**SITE PLAN REVIEW SHEET
ENVIRONMENTAL VARIANCE REQUEST ONLY**

CASE: SP-2021-0091C

PROJECT NAME: Oltorf Site Plan

ADDRESS OF SITE: 4544 E Oltorf Street

EXISTING SLOPE MAP

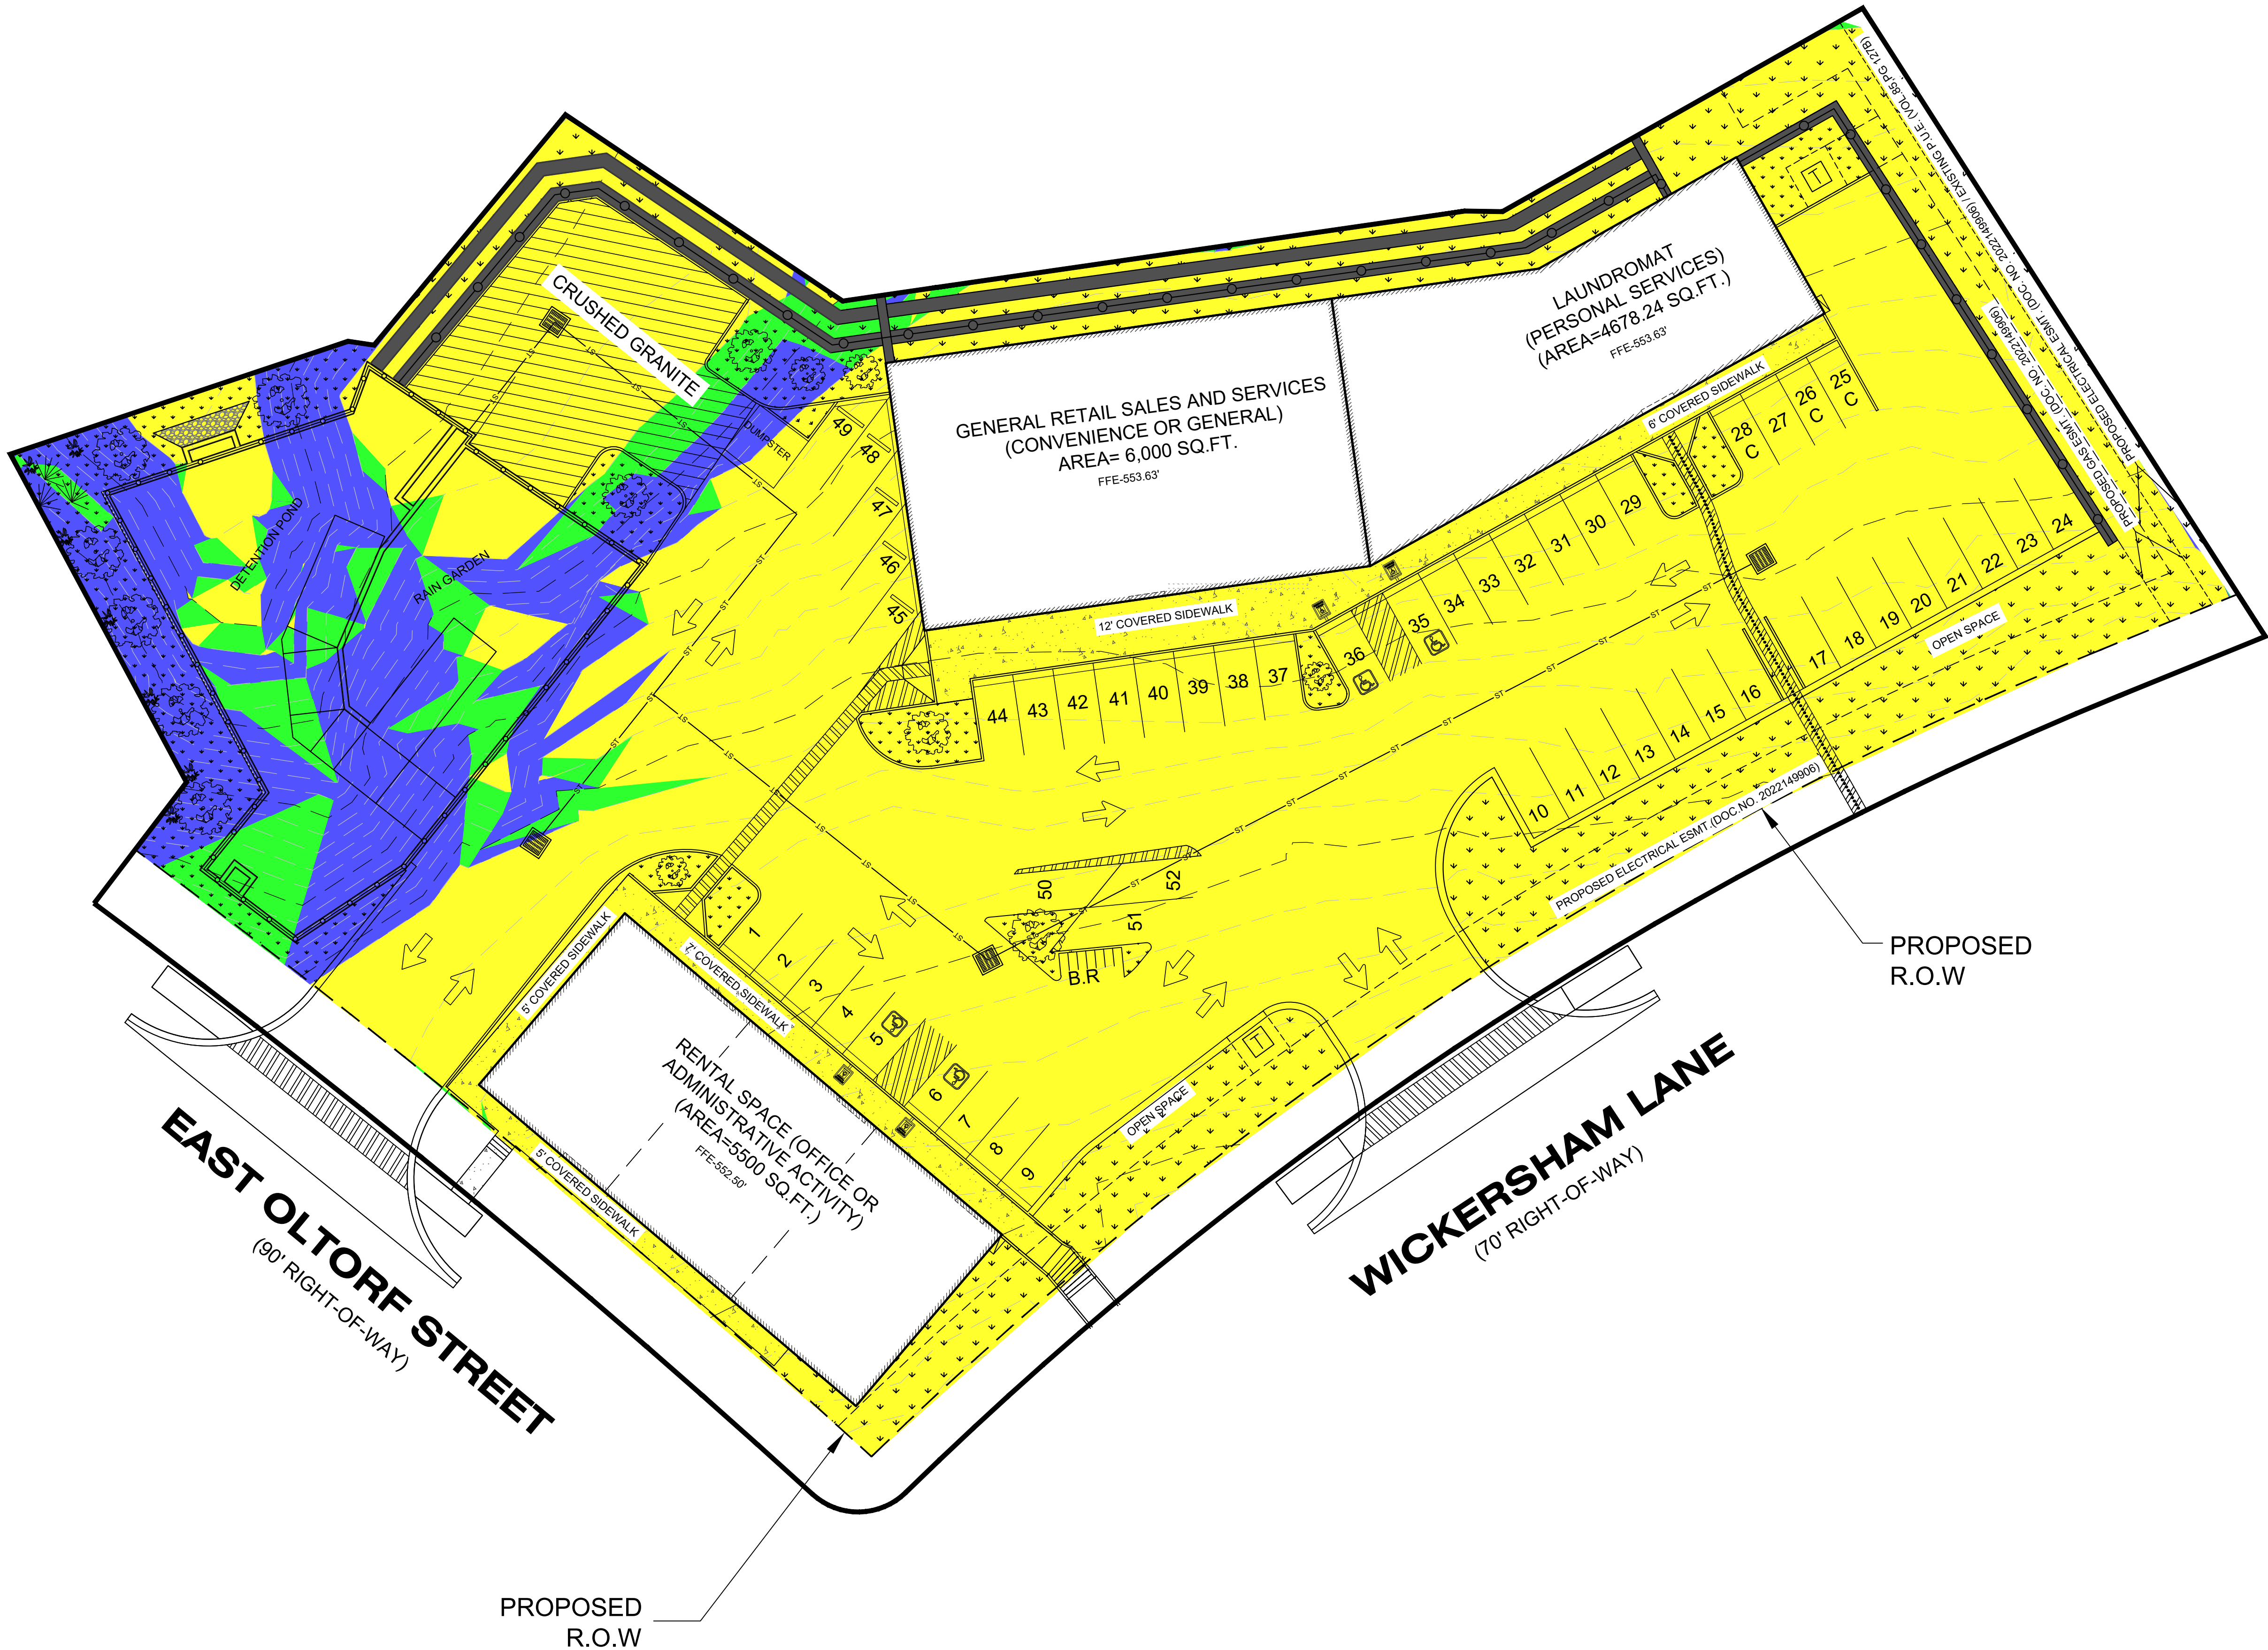
- 1) Request to vary from LDC 25-8-301 to allow driveways on slopes over 15%.
- 2) Request to vary from LDC 25-8-341 to allow cut over 4 feet up to 8 feet.
- 3) Request to vary from LDC 25-8-342 to allow fill over 4 feet up to 20.5 feet.

Yes. Existing site conditions and accessibility regulations require the only available driveway access from Oltorf to cross existing slopes that exceed 15% gradient.

Clearly indicate in what way the proposed project does not comply with current Code (include maps and exhibits)	Cuts and fills will exceed 4 vertical feet. Driveway is proposed over existing slopes steeper than 15%
---	--

- 1) Provide 8 additional trees at 3 caliper inches.
- 2) Provide structural containment of fill with retaining walls.

CUT/FILL EXHIBIT

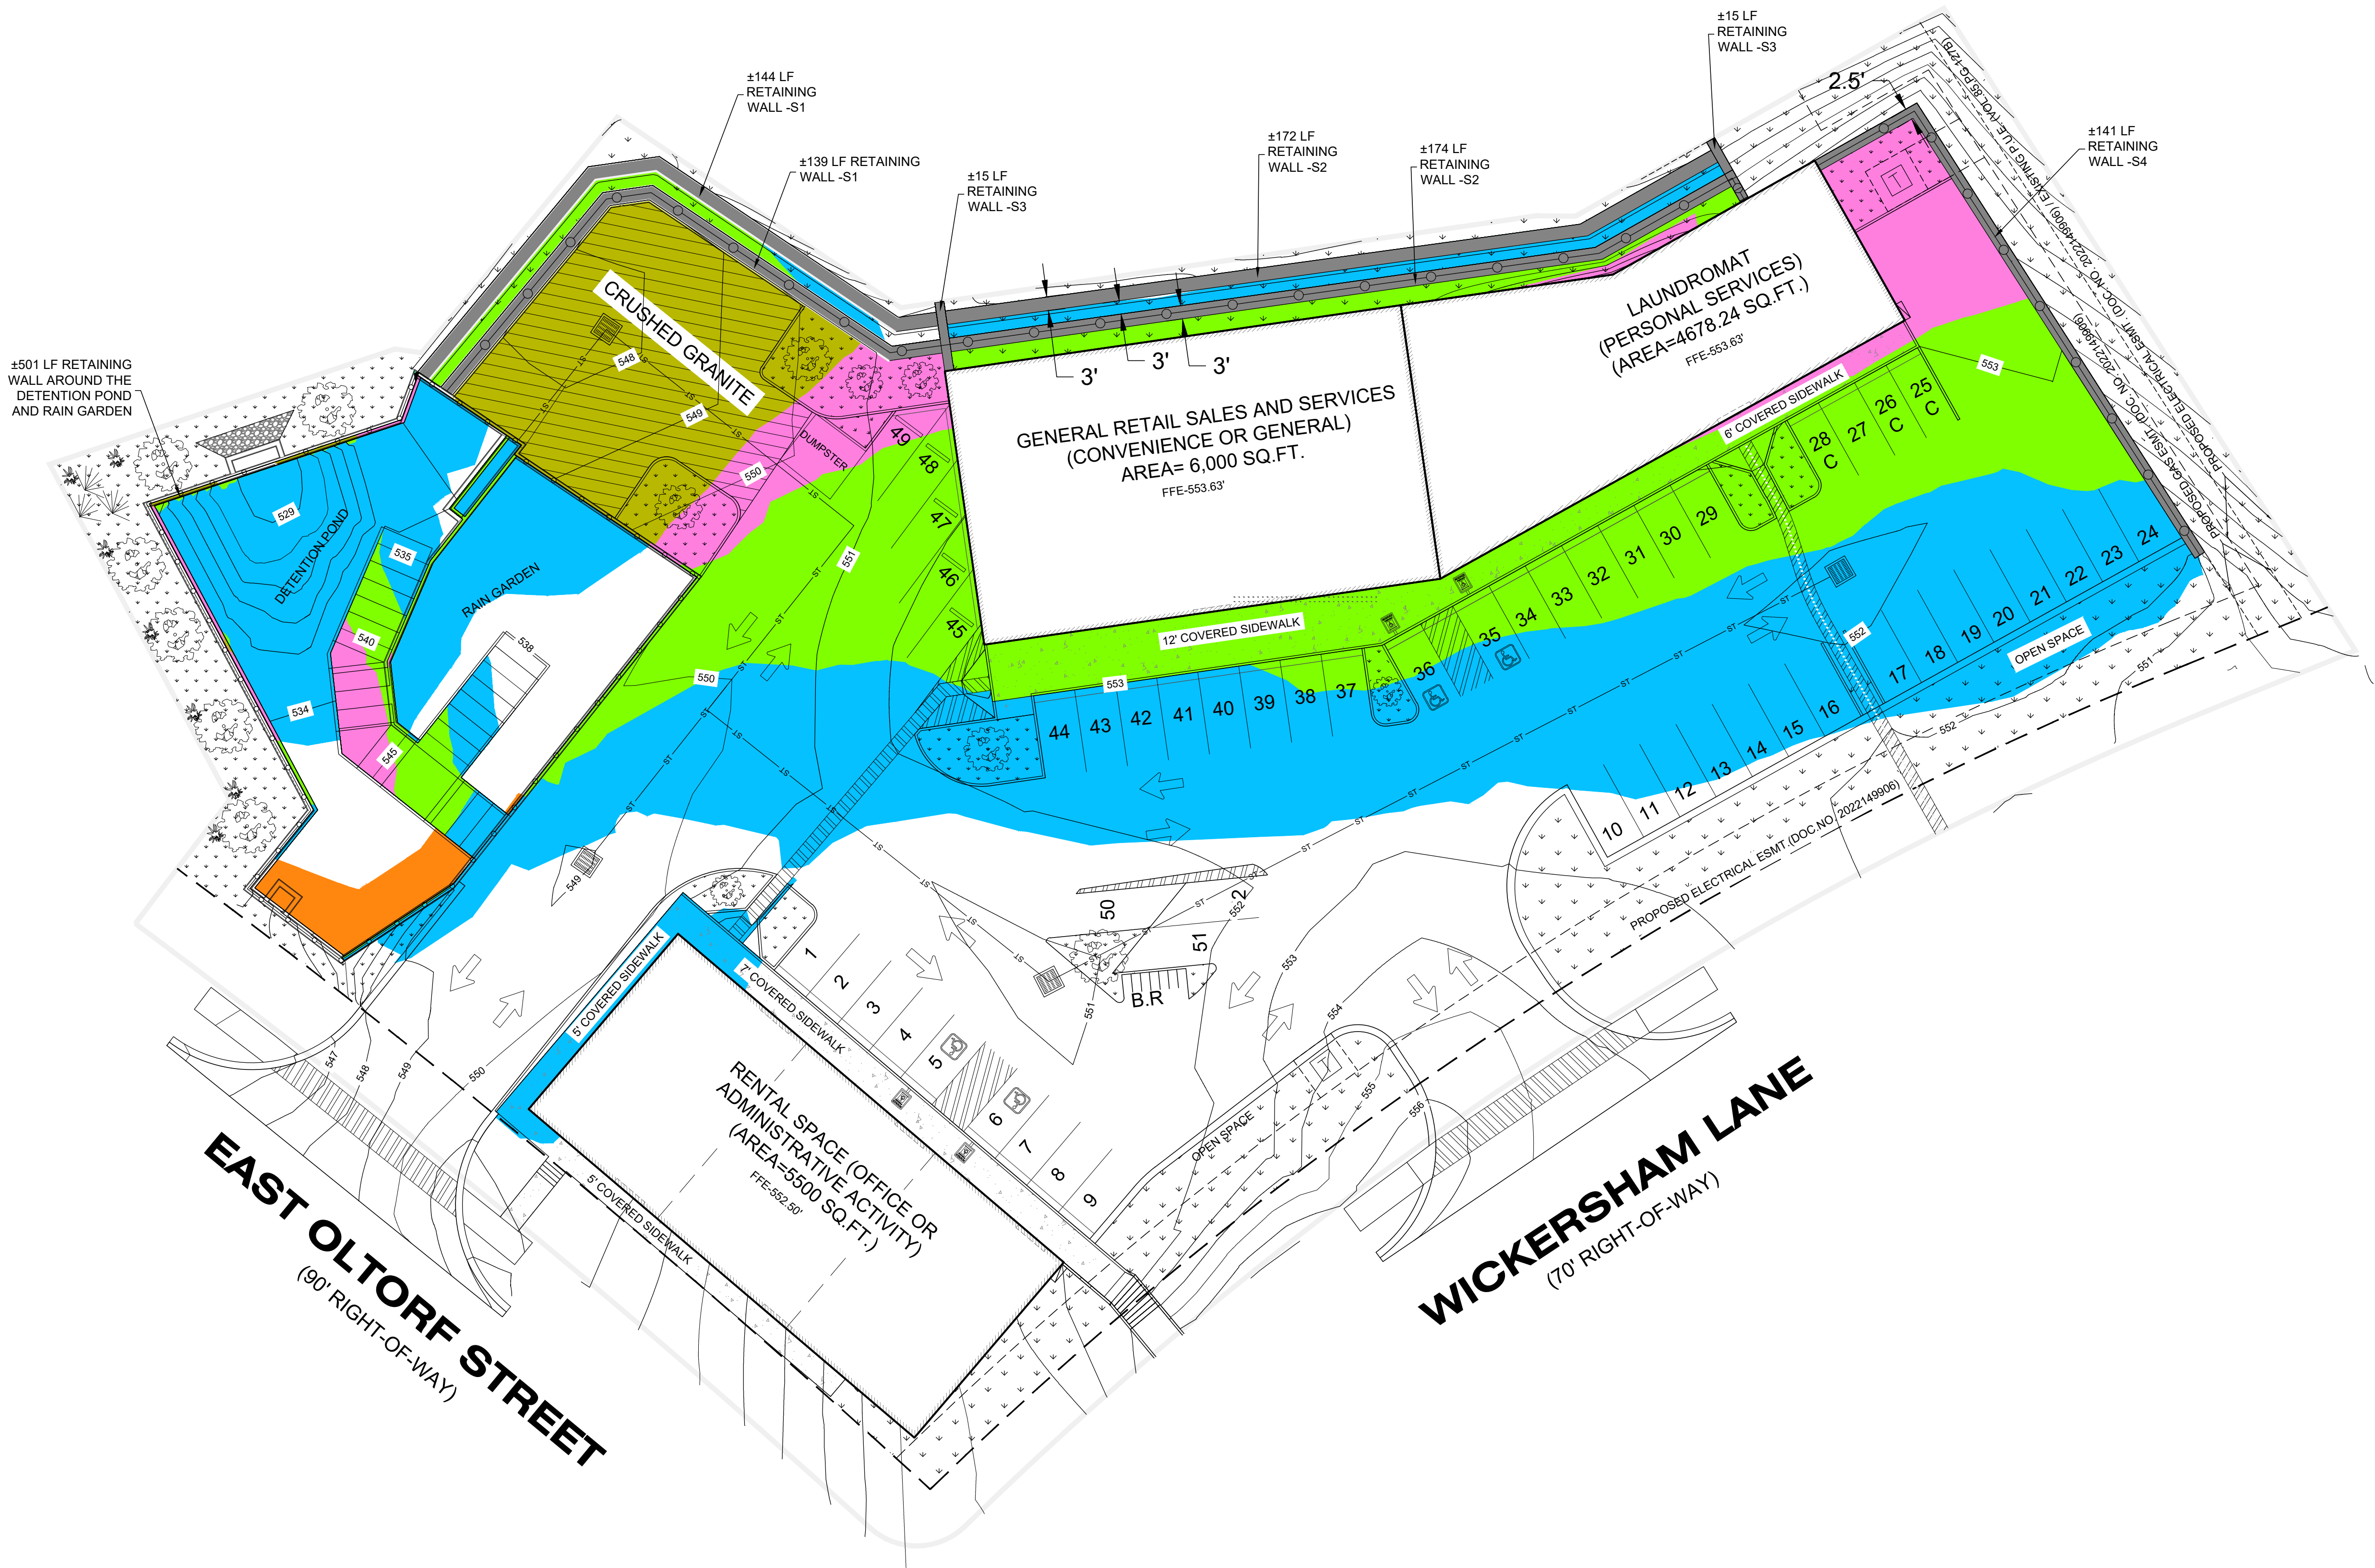
In order to facilitate this type of drainage which will require stormwater releases from detention ponds to flow into the storm sewer pipes along East Oltorf, grading within the detention/water quality area will have cut up to 8 feet and fill up to 20.5 feet.

Yes. The variance does not create a significant probability of harmful environmental consequences. The variance is a minimum deviation from code to allow for reasonable use of the property. Fill will be minimized and structurally contained with retaining walls.

outflows from the site; this requires us to grade approximately 435 square feet within the detention pond area of the site with cuts ranging between 4 and 8 feet, and to fill approximately 30,006 square feet of the site with depths of 4 to 12 feet, and to fill approximately 5,663 square feet of the site with fill to depths of 12 to 20.5 vertical feet. Significant redesigns were done in accordance with recommendations from Environmental staff, to eliminate vehicle parking spaces over original site slope gradients exceeding 15%, and to eliminate additional driveways on slopes over 15%.

- Provide 8 additional trees at 3 caliper inches.
- Provide structural containment of fill with retaining walls.
